# Roadway Plans\_V1.pdf Markup Summary

# CONSTRUCTION PLANS

CLEARWAY FILING NO. 2, LOT 5		TITLE SHEET	
PROJECT NO. 44-042A		DATE: 06-02-2022	
DESIGNED BY: DIM		SCALE: HORIZONTAL: N/A	
DRAWN BY: CLP		VERTICAL: N/A	
CHECKED BY: DIM		SHEET 1 OF 15	
TS01

**STORM 1  
STA 1+00.00 TO STA 6+72.07**

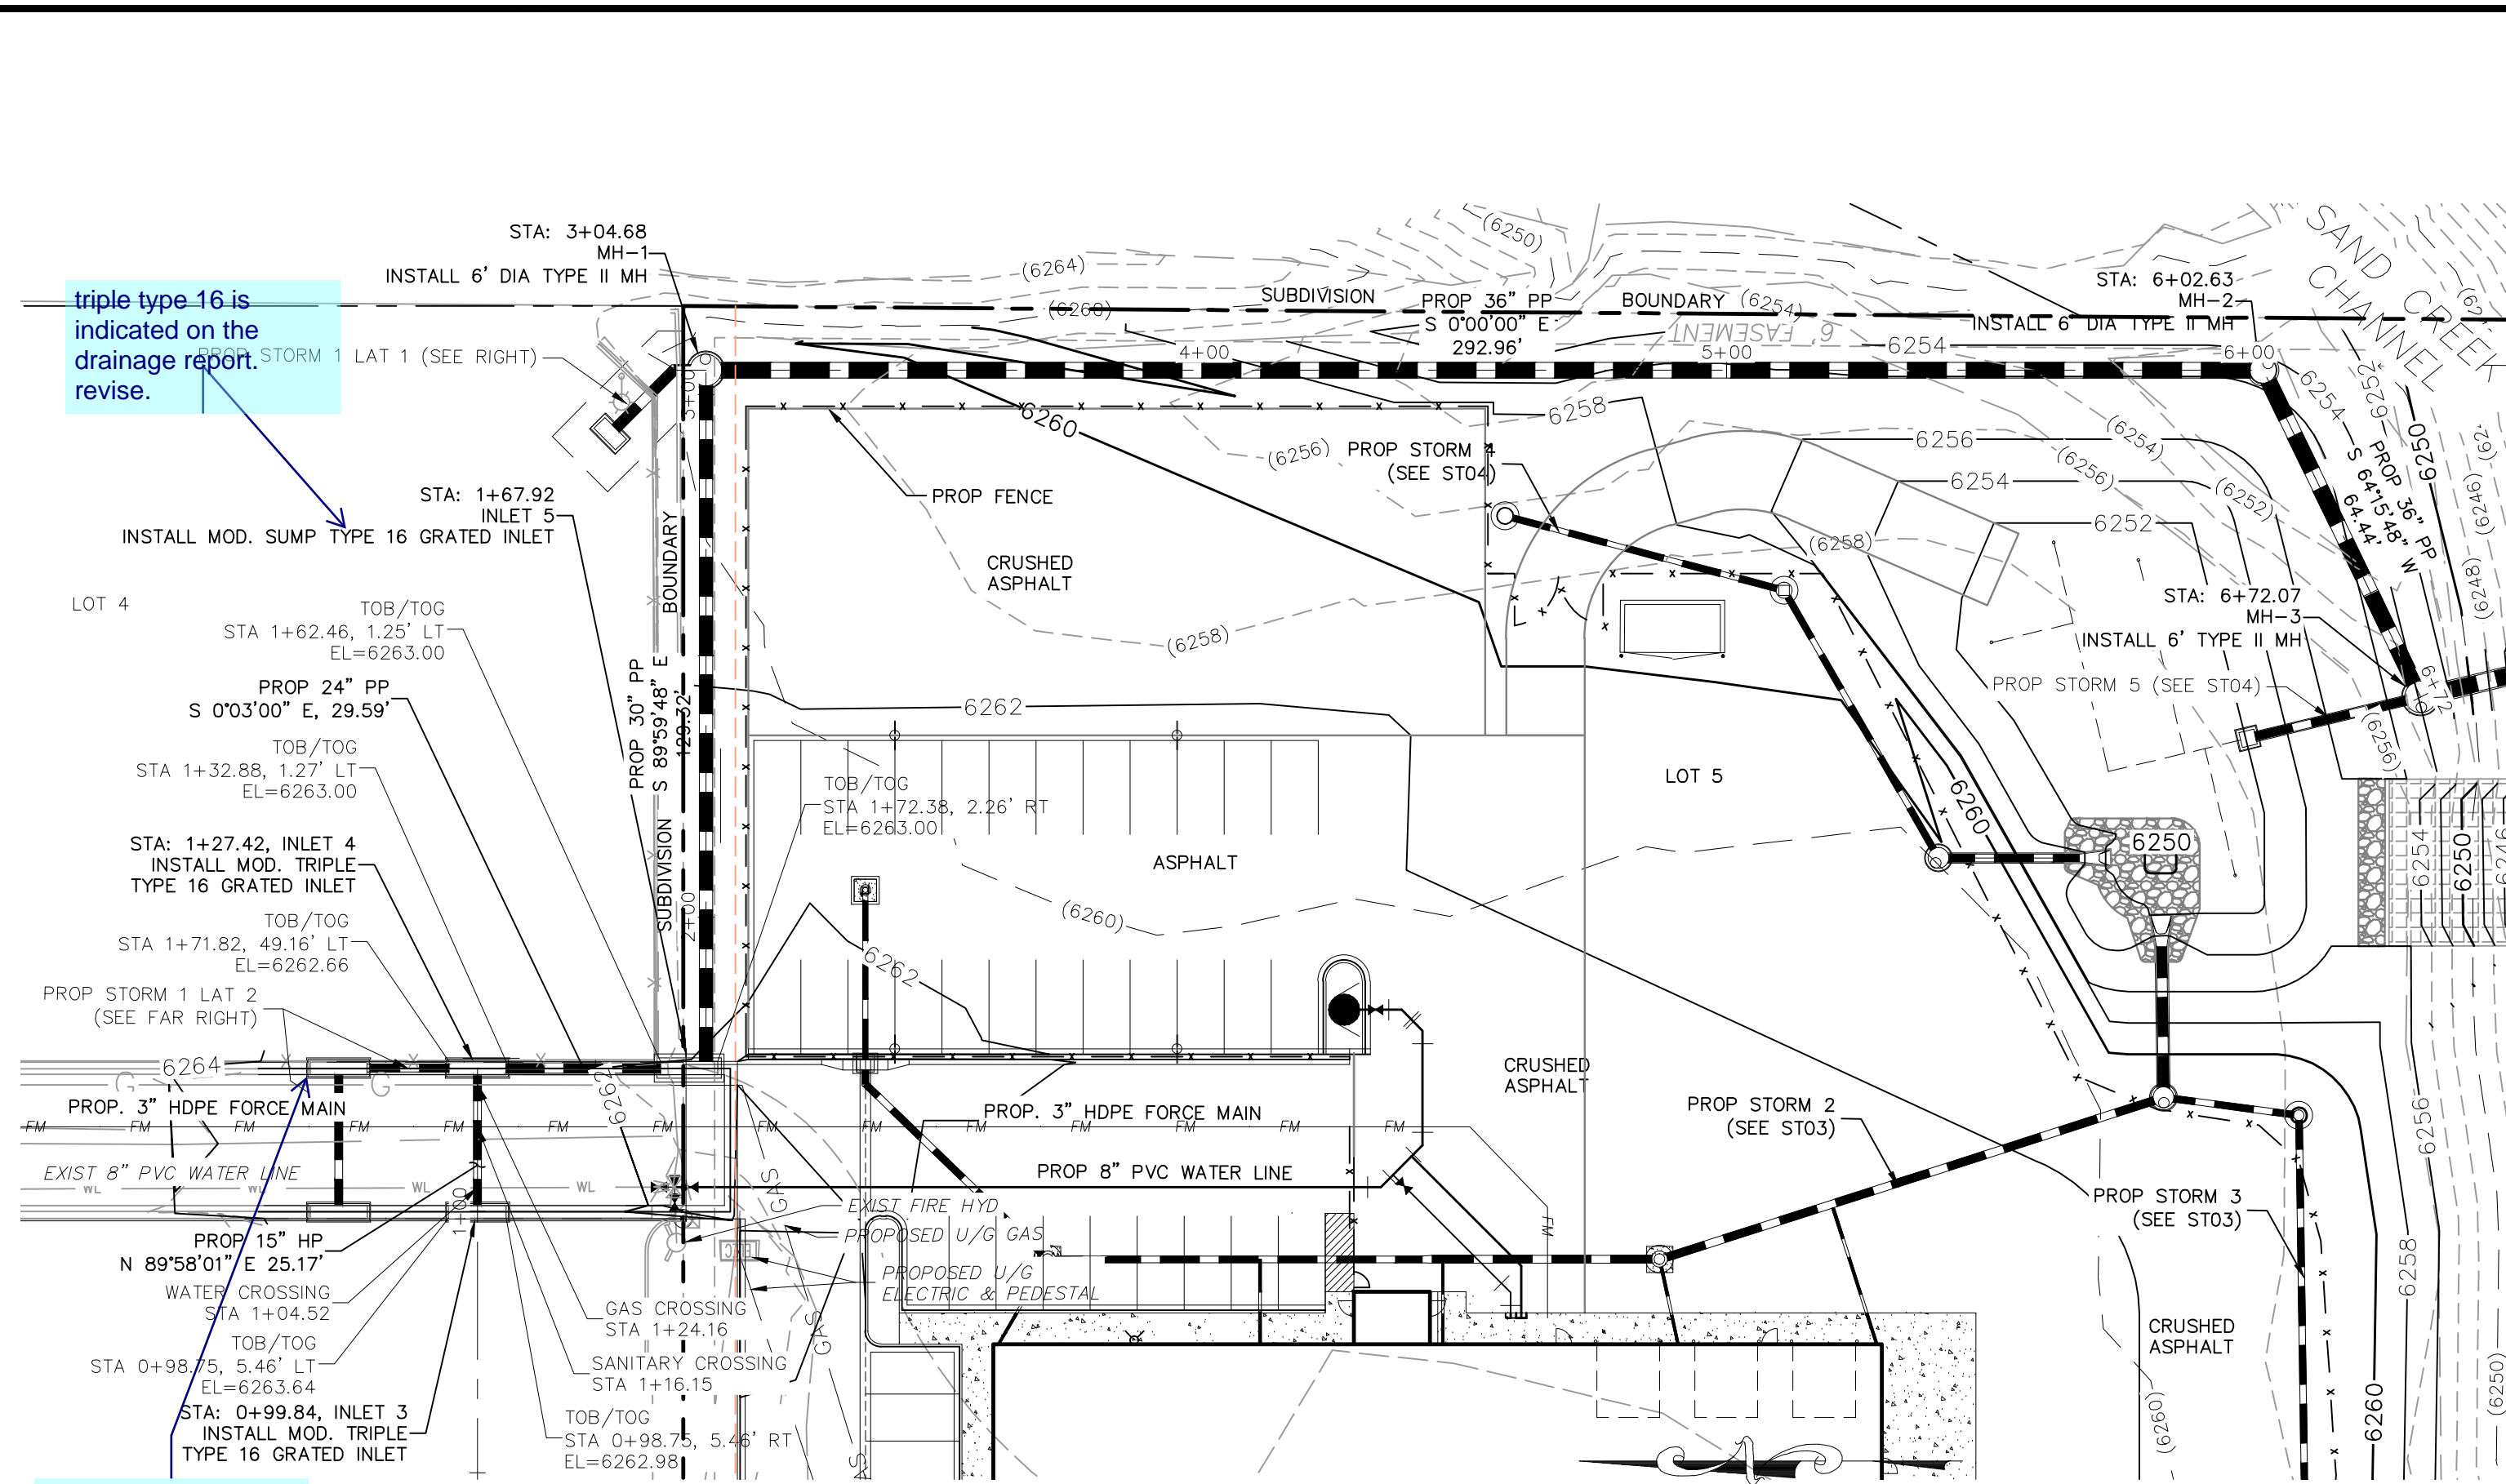
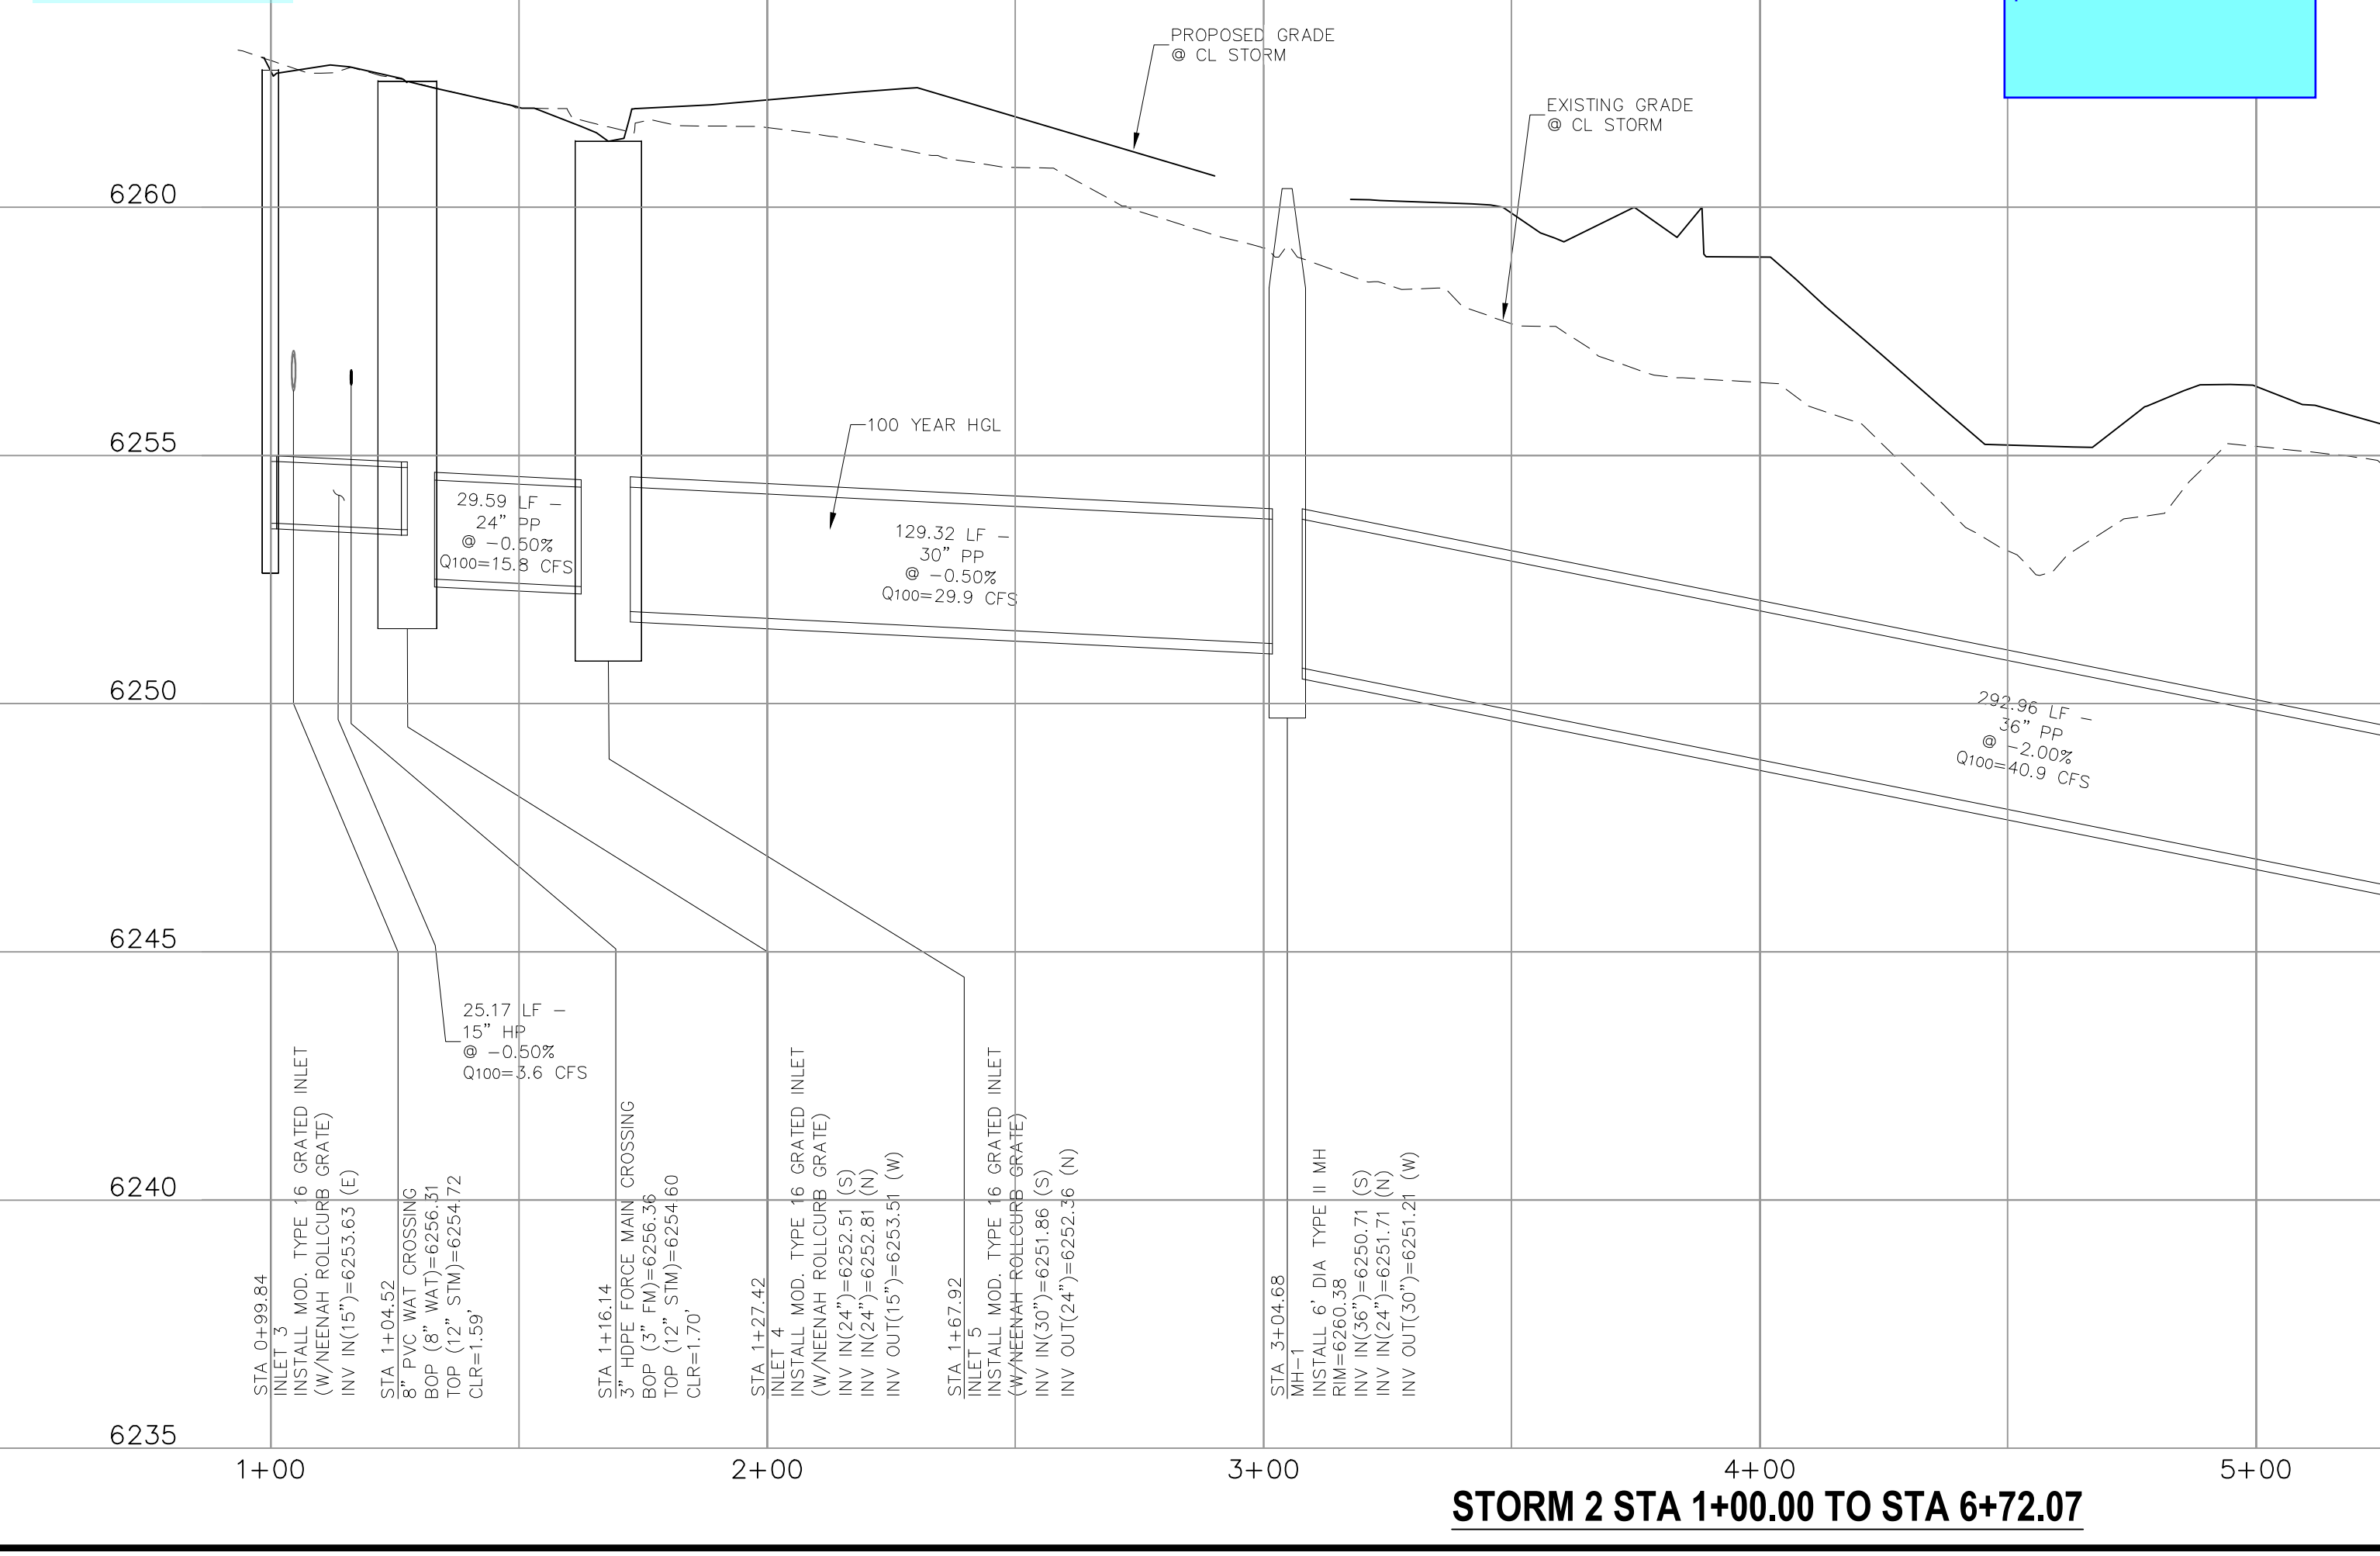
identify who will maintain the proposed inlets and storm sewers in the common easement

provide vertical scale

Show HGL lines on the profiles.  
Typical at all storm profiles.
